125C

Parts List No. 545014380		Husqvarna® PARTS LIST	MODEL 125C
Date 1/02/07	Replaces 545014380 - 10/27/06		NOTE : Illustration may differ from actual model due to design changes.

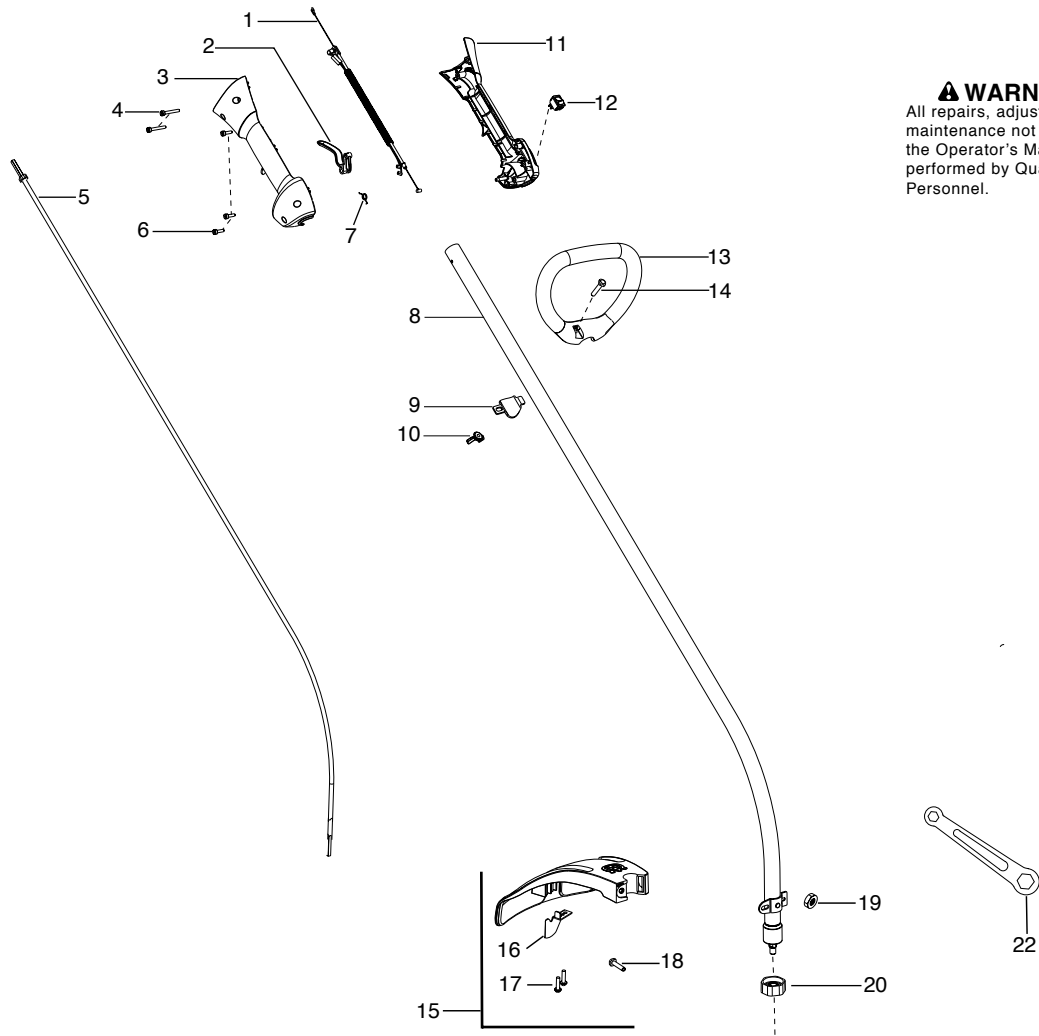
Note : Due to product improvements, your unit may have a different clutch drum assembly and flexshaft. Please refer to the serial number on your unit and order the parts below.

Note : Due to product improvements, your unit may have a different cable assembly and air box. Please refer to the serial number on your unit and order the parts below.

Serial Number - 2006-273N and lower, please use the following parts:
 Page 1, Ref.# 5 - 545081804 Kit - Clutch drum & flexshaft
 Page 2, Ref.# 51 - 545081804 Kit - Clutch drum & flexshaft

Serial Number - 2006-274N and higher, please use the following parts:
 Page 1, Ref.# 5 - 545007508 Flexshaft
 Page 2, Ref.# 51 - 530150039 Assy-Clutch drum

Serial Number - 2006-059N and lower, please use the following parts:
 Page 1, Ref.# 1 - 545050414 Kit - Air box with cable wire harness assembly
 Page 2, Ref.# 3 - 545050414 Kit - Air box with cable wire harness assembly

Serial Number - 2006-060N and higher, please use the following parts:
 Page 1, Ref.# 1 - 545125301 Assembly-cable wire harness
 Page 2, Ref.# 3 - 545084601 Air box
